TRANSMITTAL OF DEFENSE NUCLEAR FACILITIES SAFETY BOARD (DNFSB)  
RECOMMENDATION 2010-2 IMPLEMENTATION PLAN (IP) DELIVERABLE 5.5.3.5

**Waste Feed Delivery Mixing and Sampling Program Simulant  
Definition for Tank Farm Performance Testing,  
RPP-PLAN-51625, Rev. 0, dated 03/20/12**

- **LSIMS ERT Document Review Record, ERT-12 Feed Simulant Defn., “Waste Feed Delivery and Sampling Program Simulant Definition for Tank Farm Performance Testing,” RPP-PLAN-51625, Rev 0a. (12 pages)**

ONE SYSTEM TECHNICAL TEAM RESPONSE TO REVIEW OF WASTE FEED  
DELIVERY AND SAMPLING PROGRAM SIMULANT DEFINITION FOR TANK FARM  
PERFORMANCE TESTING (ERT-12)

**Figure 6-1. Cumulative Volume Distribution of Hanford Waste Liquid Density**

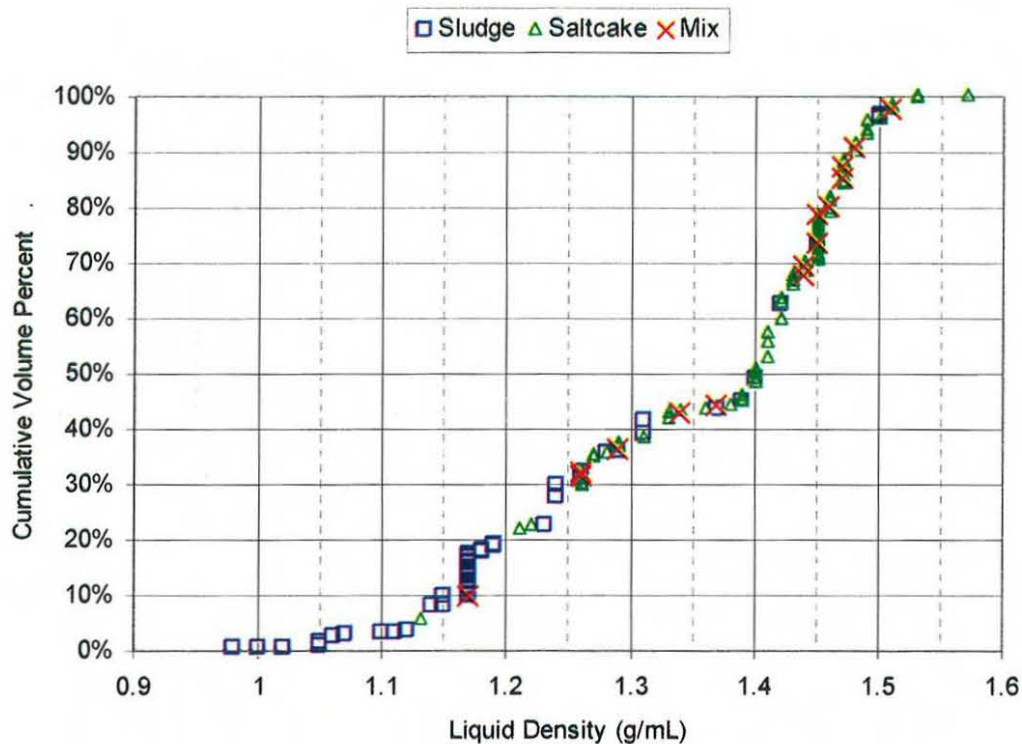
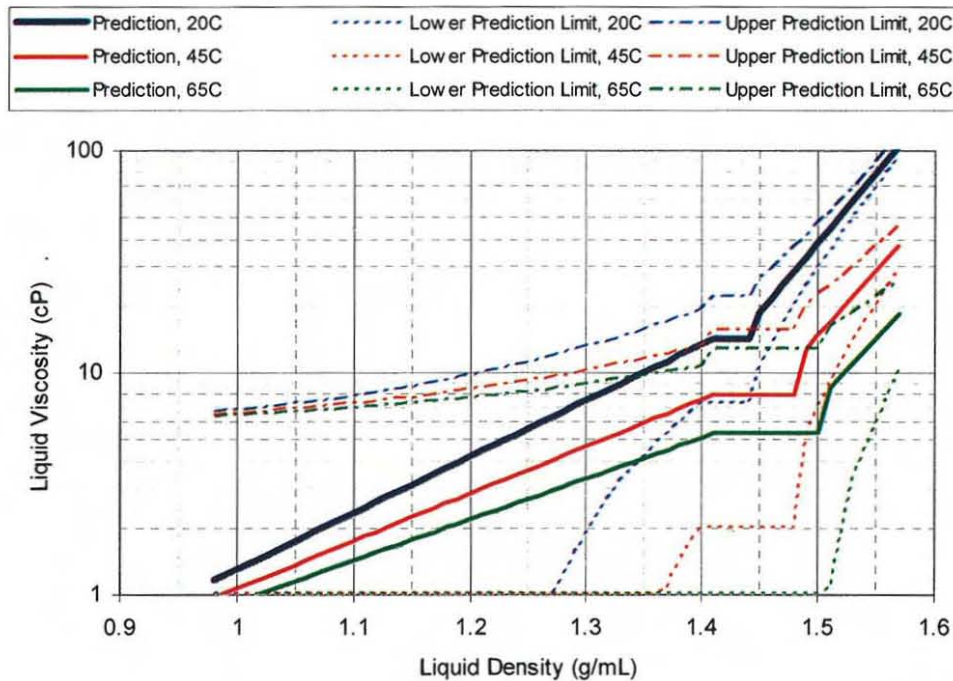
33	RVC	E	Section 6: Some captions and figures need to be re-aligned.	Corrected
34	RVC	O	Figures 6.1 & 6.2: In the figures, is there an interdependence between density and viscosity? Or can any combination of wastes yield a particular density?	See the discussion in Section 6.1
35	RVC	E	p.23, 3 <sup>rd</sup> paragraph: Numerous incorrect references to Figures.	Corrected
36	RVC	O	Naïve question: Why is the waste Bingham? Am I wrong to suspect that tank farm wastes may have sufficiently deviant rheology?	The Bingham rheological model is considered imperfect, but appropriate for these purposes.
37	RVC	O	Section 6.2: Figs.6.3 to 6.14 are too much, especially given the scatter plot like nature of the non-cumulative plots. Dealing with them diffuses the message, so except for a few, examples, they should be put in an appendix.	This section has been modified.
38	RVC	O	Section 6.2: If expected trends do not always occur, what does that say about the quality, accuracy and representativeness of the data?	This section has been modified for clarity.
